AMENDMENTS TO THE DRAWINGS

REMARKS/ARGUMENTS

F I G . 1

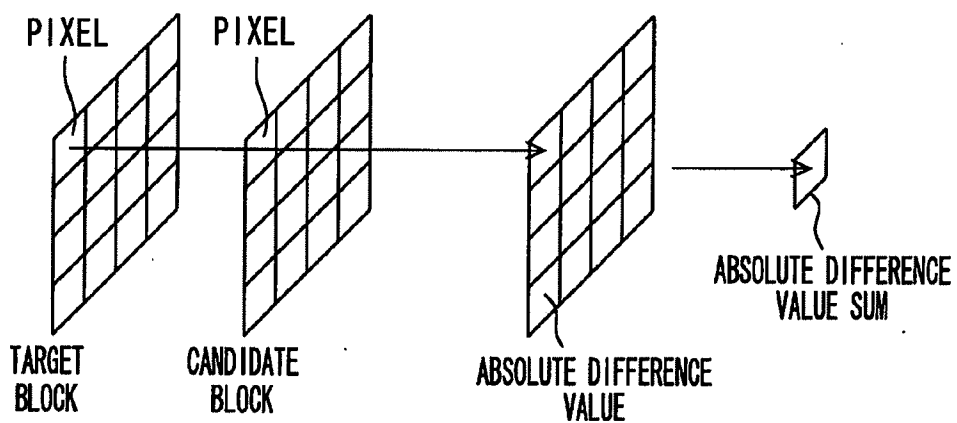
The attached sheet of drawings includes changes to Figures 1-4. The sheets which include Figures 1-4 replace the corresponding original sheets. The legend "PRIOR ART" has been added in each of the figures.

PRIOR ART
